CITY OF WICHITA

Re: BZA2013-25: City zoning administrative adjustment to reduce the parking requirement by up to 25%, from 49 to 44 spaces, in LI Limited Industrial zoning, for an industrial building expansion, generally located west of Lulu and north of 49th Street South (4999 Lulu).

Addition to Elliot Lekawa Tenant Lease Building

Site Layout Plan

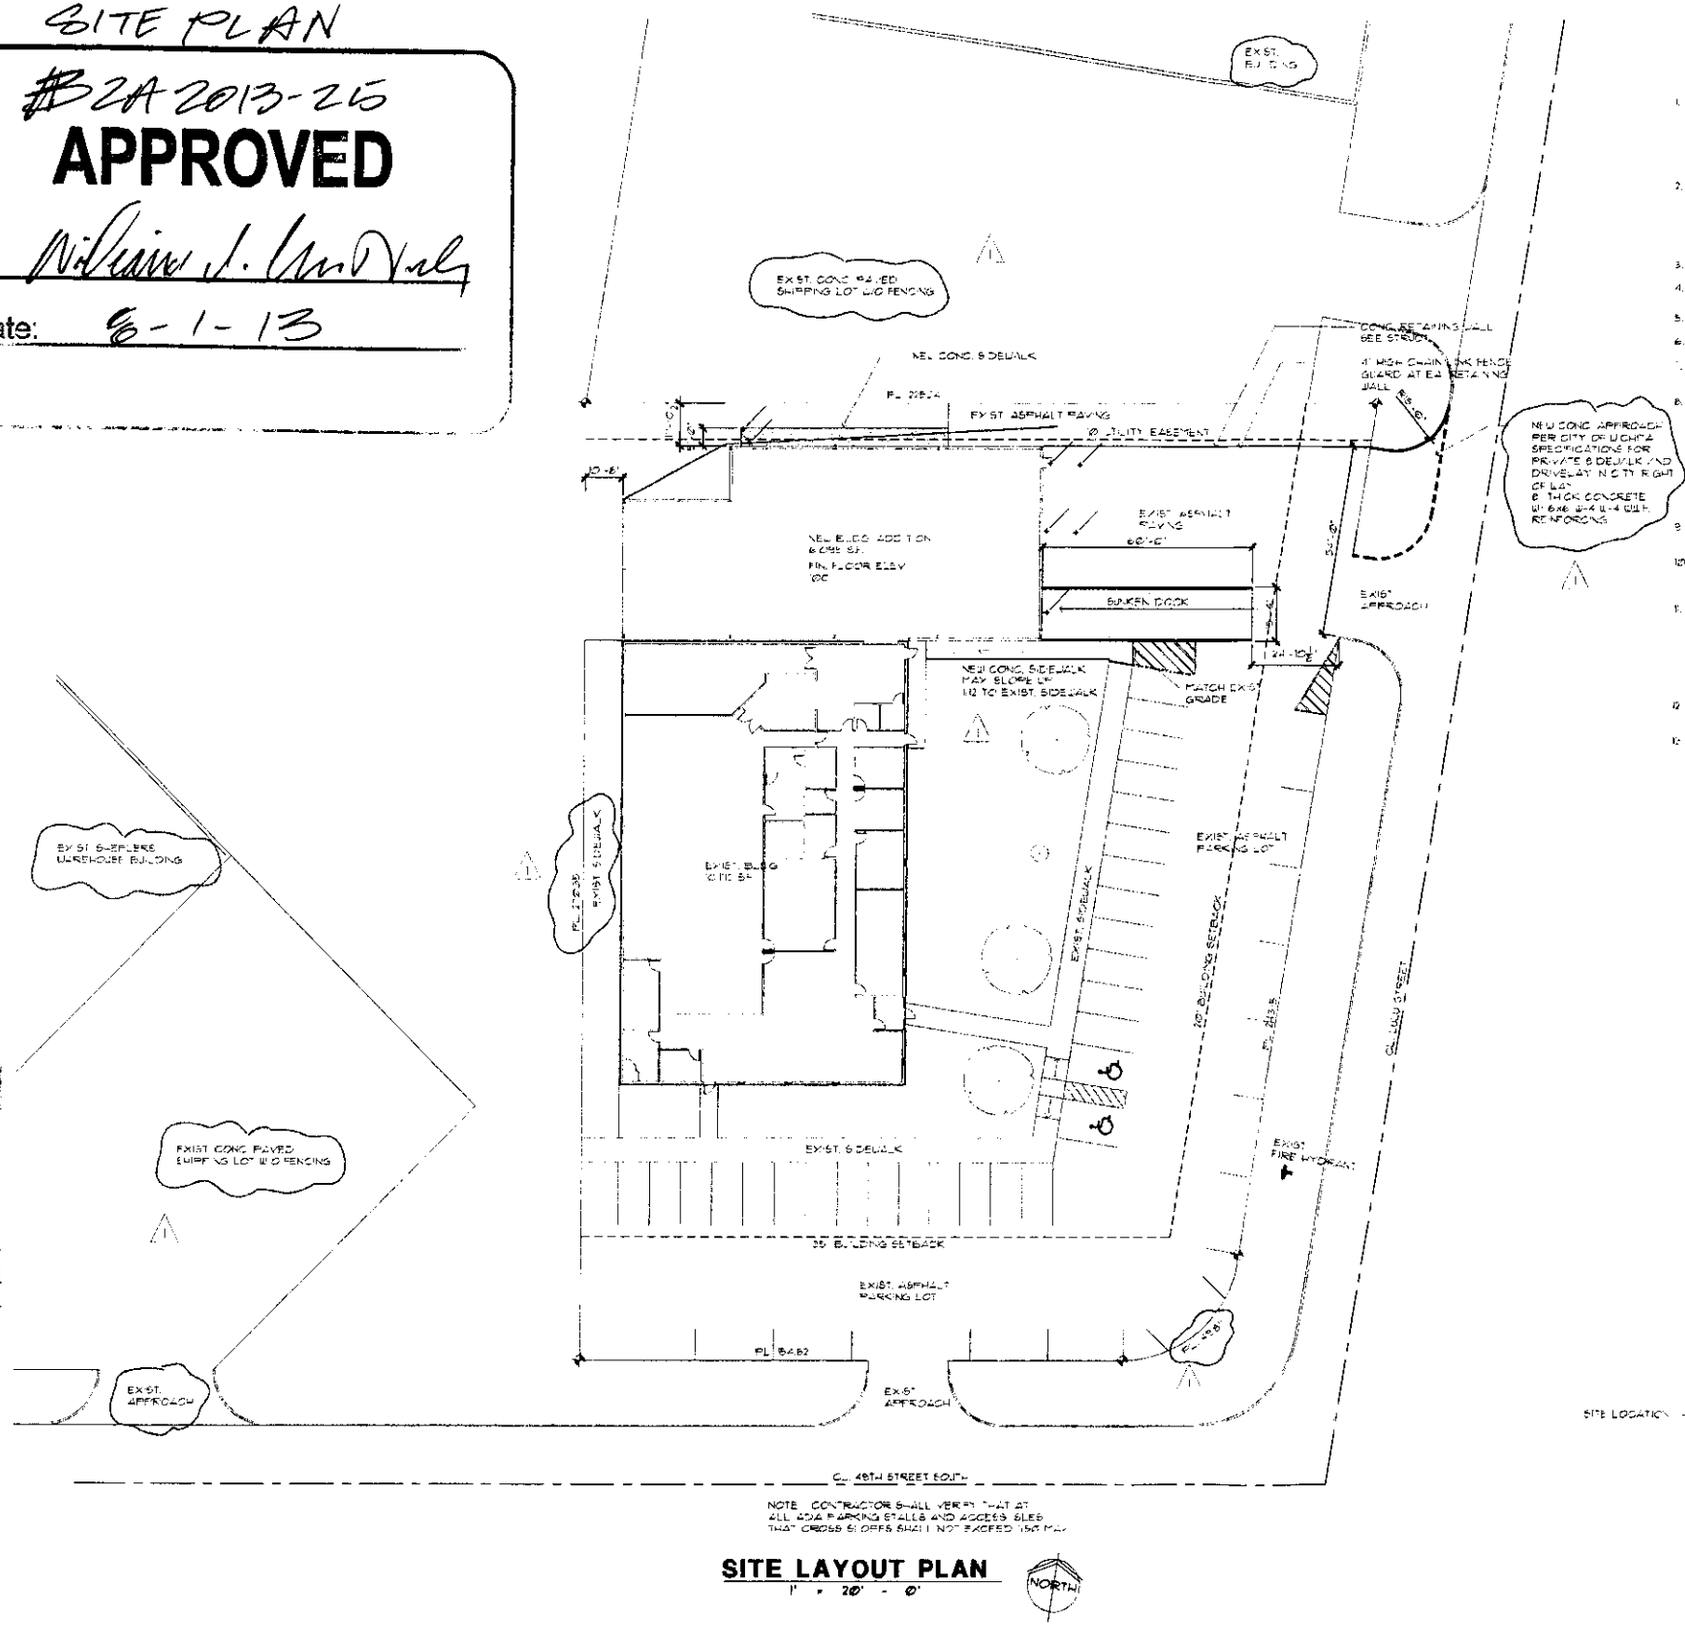
We reviewed your Zoning Adjustment request to reduce the parking requirement on the above-referenced property. From reviewing your application we understand that you propose a building addition on the subject site. You indicate a desire to reduce the on-site parking requirement from 49 to 44 spaces, an 11% reduction of the Unified Zoning Code (UZC) requirement for the site.

Sec. V-I.2.i of the Unified Zoning Code allows an adjustment to reduce the parking requirement for renovation projects by up to 25% when the conditions required by Sec. V-I.6 of the Code are met. We find that the parking requirement reduction as proposed meets the four conditions required by Sec. V-I.6 of the Code as set out below:

1) Impact on safety and convenience of vehicular and pedestrian circulation: The proposed reduction in parking requirement should have no impact on the safety and convenience of vehicular and pedestrian circulation in the vicinity of the application area. Sufficient parking should be available for the anticipated need, and the parking does not interfere with public right-of-way.

2) Impact on existing uses in surrounding areas: The proposed reduction in parking should not impact existing uses in surrounding areas, as all parking for this project should be adequately provided on the site.

3) Compatibility with existing or permitted uses on abutting sites: An 11% parking reduction should not compromise existing or permitted uses on abutting sites, as all parking for this project should be

adequately provided on the site.

4) Effect on public health, safety or welfare: There will be no encroachment into public right of way or utility easements; the public's safety, health and welfare should not be impacted.

Our signatures below indicate that an administrative adjustment to reduce parking by 11%, from 49 to 45 spaces is hereby granted for the aforementioned property subject to the following conditions:

1) The site shall be developed in general conformance with the approved site plan.
2) All parking on the site shall be paved and marked in accordance with City standards.
3) If the Zoning Administrator finds that there is a violation of any of the conditions of the Zoning Adjustment, the Zoning Administrator, in addition to enforcing the other remedies set forth in the Unified Zoning Code, may, with the concurrence of the Planning Director, declare that the Zoning Adjustment is null and void.
